**DESIGN REPORT**  
*FOR*  
**BURKE CREEK HIGHWAY 50 CROSSING AND  
REALIGNMENT PROJECT, PHASE I**  
*STATELINE, NEVADA*

**May 2016**

Comments on Burke Creek HWY 50 Crossing and Realignment Project				
			Commenter: Erik Nilssen P.E., Douglas County	Responder: NTCD Engineering
Comment #	Document	Page	Comment	Response
DC-1	90% Plans	G-1	I am hesitant to use the Bluth property as staging. Mr. Van Bieskirk has threatened an injunction on the project. I would show the Douglas County parking area as staging and put in the specifications under "staging" that additional staging locations will be the responsibility of the contractor.	The 100% Plans have been changed to show the Apartment 801 LLC property as access only. Additionally, text has been added to the special provisions to require owner's permission for storage and staging.
DC-2	90% Plans	G-2	Leader lines for details 4/D-7 and 1/D-1 and 5/D-2 are pointing to the incorrect location	Details have been revised for 100%
DC-3	90% Plans	G-3	The abandonment of the existing stormdrain should go back to the existing catchbasin in the driveway. If we do not wish to remove the CMP, it should be filled with concrete to the catchbasin	Plans a

DESIGNED/DRAWN DS/PK
CHECKED MK/MG
DATE 6/24/2015
SCALE AS SHOWN
PROJECT BCC
SHEET CS-7 12 of 19

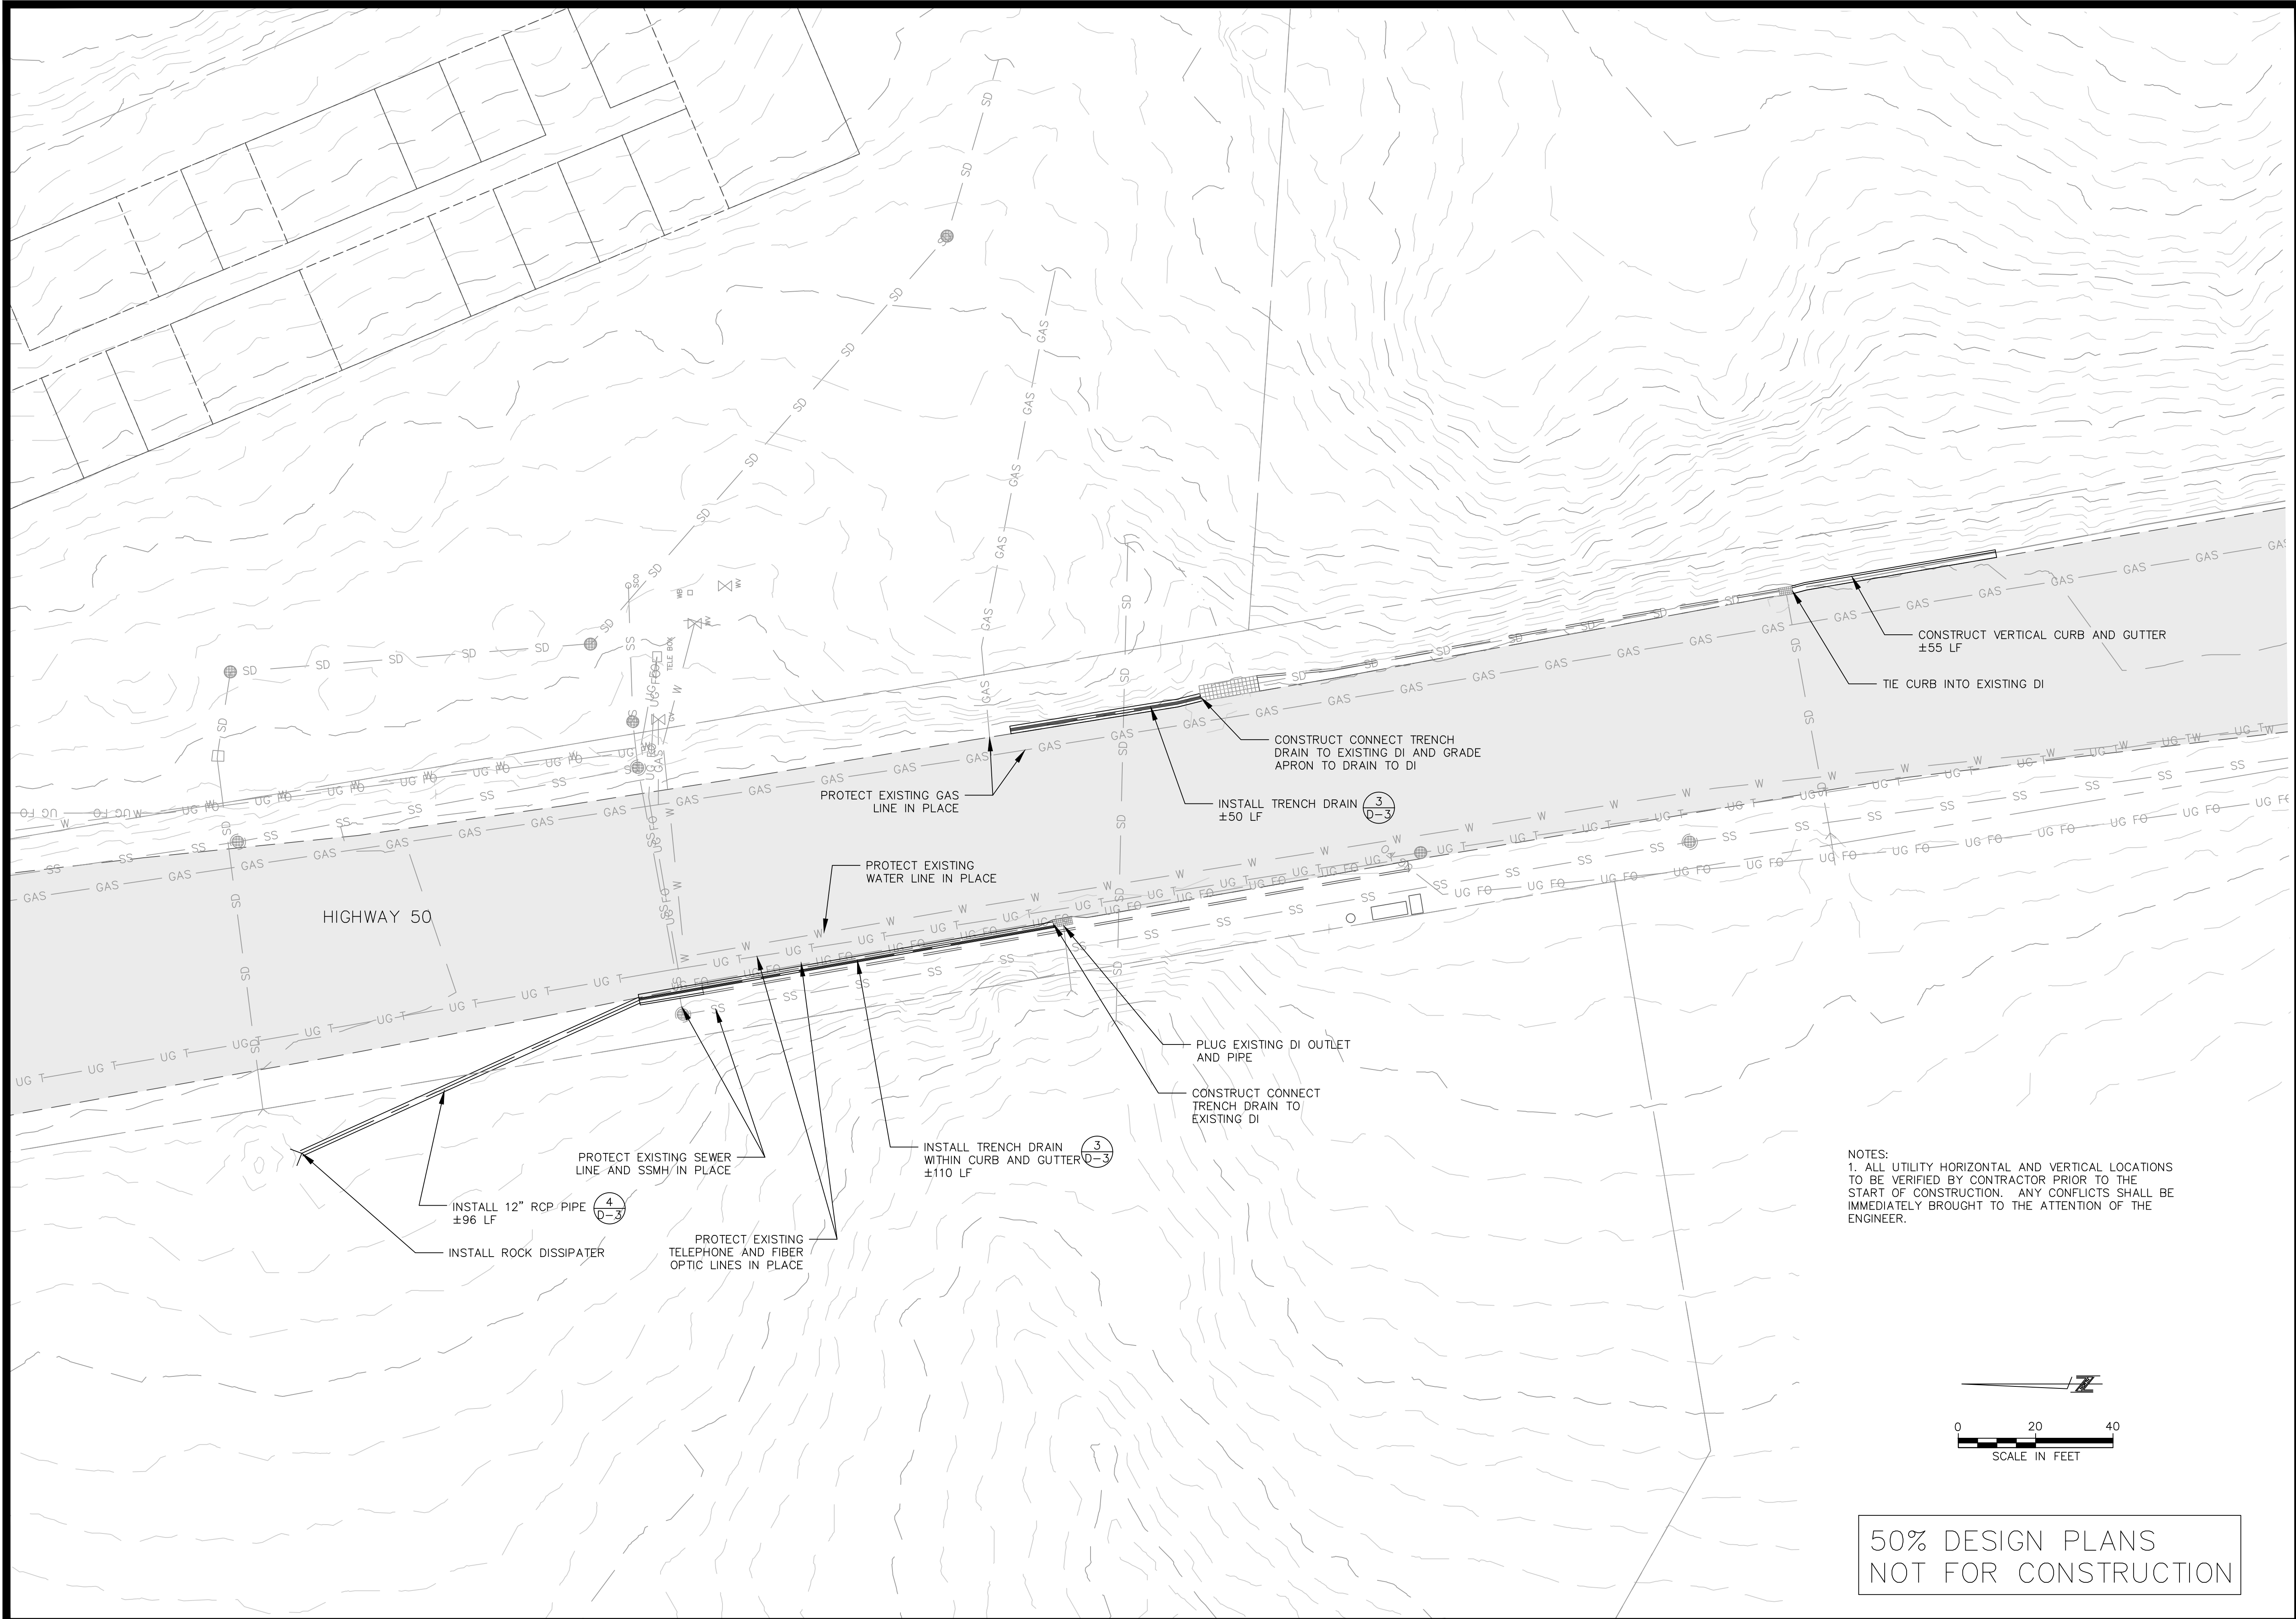
NDOT-6	90% Plans	C-8, #5	15" minimum	Design has been revised for 100%
NDOT-7	90% Plans	C-8, #6-7	Show channel tapers (narrows) as it get further from culvert	Channel width has been tapered from the culvert outlet to the 2' wide channel for first 10' of channel for 100% design
NDOT-8	90% Plans	C-8, #10	Call out/label riprap thickness	Design has been revised for 100%
NDOT-9	90% Plans	C-8, #11	The width should at least be as wide as the proposed culvert span and then transition to a 2' width.	Channel width has been tapered from the culvert outlet to the 2' wide channel for first 10' of channel for 100% design
NDOT-10	90% Plans	C-9	Is there enough depth in the existing DI to connect 70' of sloping trench drain?	Yes. The 70' long trench drain with a 6" grate will have a 0.7% slope and is capable of conveying 1.3 cfs, which is well above the 100 year peak flow for design subcatchment 2. The trench drain detail has been revised to include depths for the 100% design
